RECEIPT DATE: 2-1-18 **ONSITE SEWAGE DISPOSAL SYSTEM** P 562419

SUBDIVISION: Five Hills Farm LOT: 3 TAX ID: \_\_\_\_\_

RE: Five Hills Farm, Lot 3  
13900 Old Frederick Rd.  
Sykesville, MD 21784  
*(Septic Plan Comments)*

**SEPTIC PLAN**  
**FIVE HILLS FARM, LOT 3**  
ZONED RC-DEO  
TAX MAP No. 9 GRID No. 7 PARCEL No. 117  
FOURTH ELECTION DISTRICT HOWARD COUNTY, MARYLAND  
SCALE: AS SHOWN DATE: AUGUST, 2017  
SHEET 1 OF 1

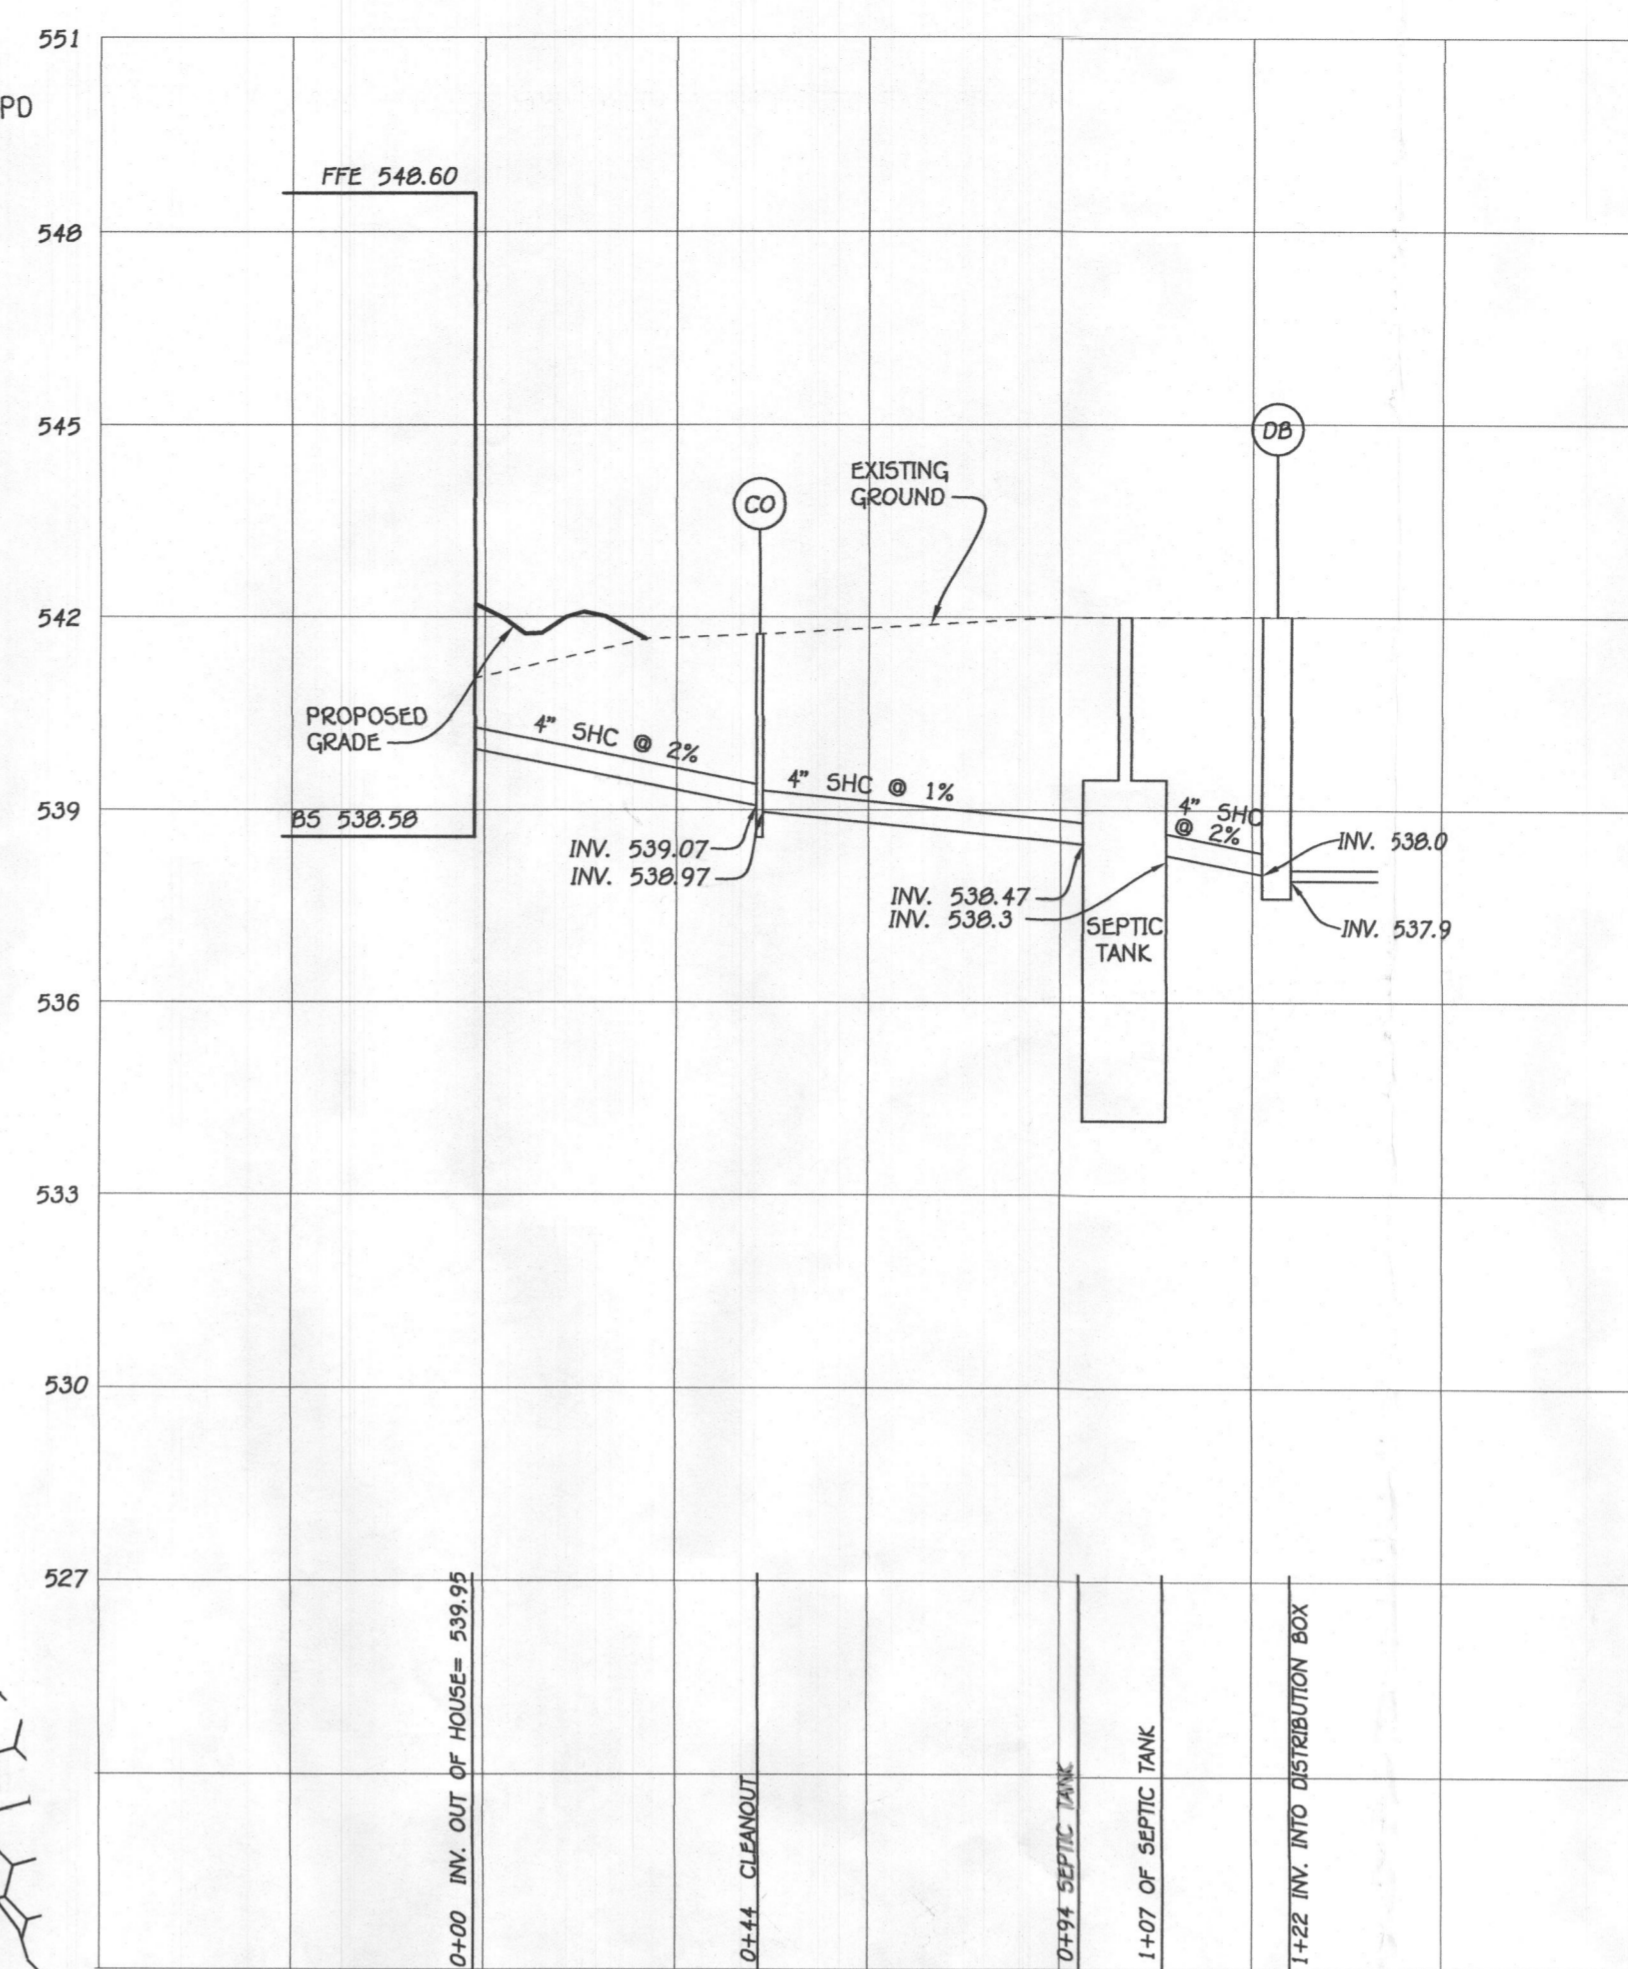
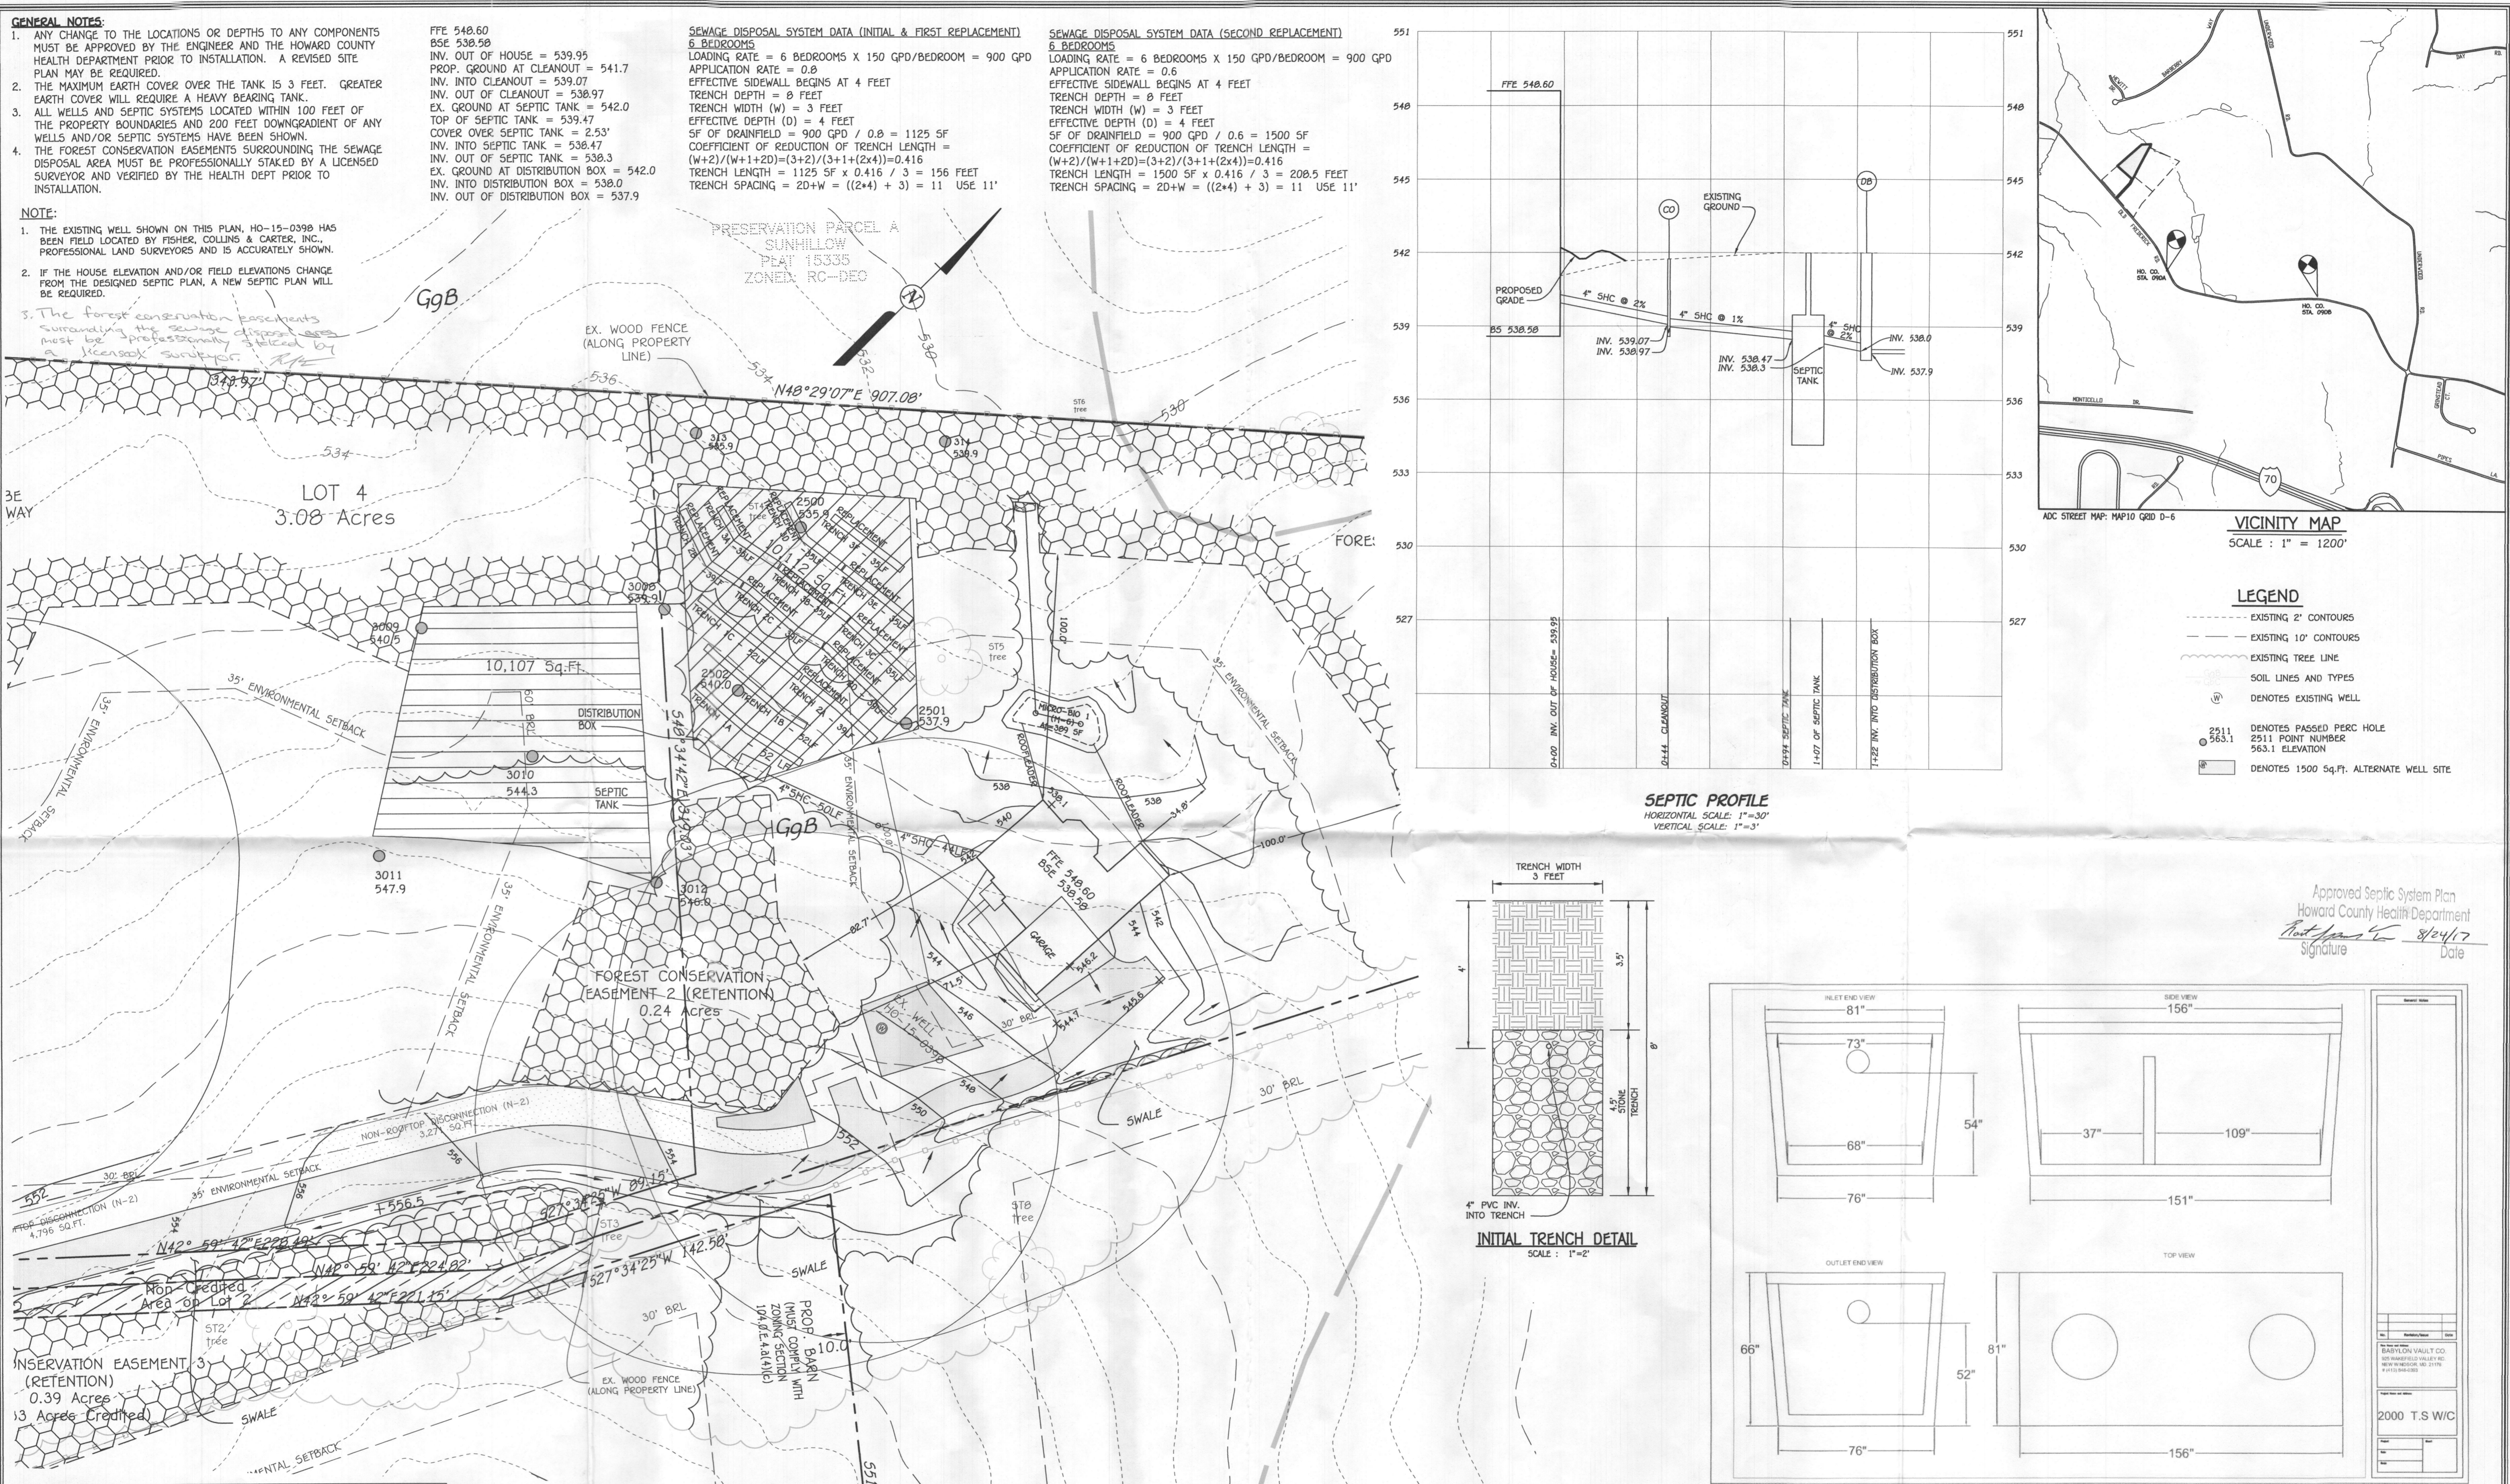
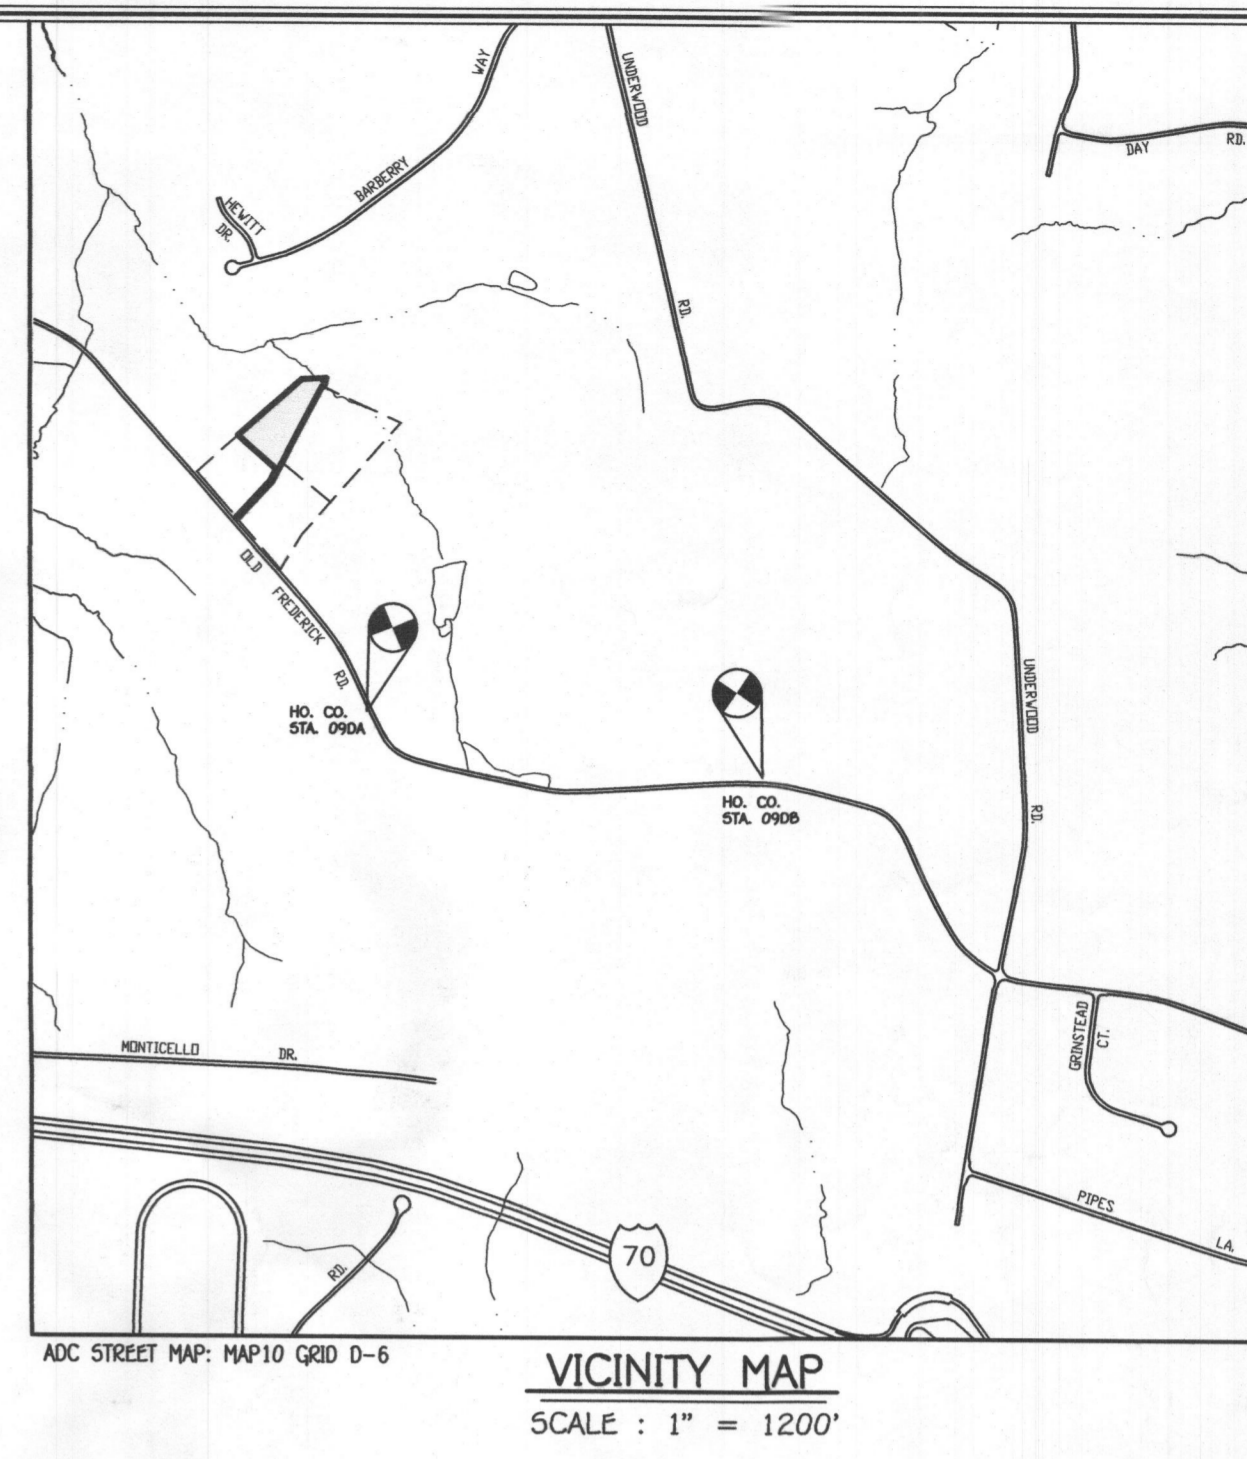
- Add the note: "All septic system components including the future pump tank and replacement trenches must be staked prior to installation."
- Raise the inlet of the initial trenching system to 3.5ft below grade. Placing the inlet higher allows for more efficient use of the effective sidewall.
- The FFE and BSE on the site plan are not consistent with the listed elevations.
- The dbox outlet elevation shown in the septic profile is not consistent with the listed elevation.

In looking at the emailed plan and discussing the field conditions with Sarah, it seems like there is still a disconnect between what is being shown on the plan and what the reality is on the ground. The actual depth of the tank lid in the ground out there was measured at 5', while the plan shows a tank lid depth of 4'. Furthermore, the contractor informed us that he was unable to achieve a 5' top trench depth from the installed d-box. The plan shows the top trench moved down the hill ½ foot and achieving a 4.5' inlet, which is not possible under the actual field conditions.

Based on what we know about the actual depths from the house to the tank and d-box, it looks to me like the only option is to design a plan with a tank down the hill and pumped up to a d-box that is installed at a shallower depth with trenches up as high as possible (not overlapping the hole from the original tank install). Keep in mind that a tank location must be 25' from a rain garden and pipe outfall.
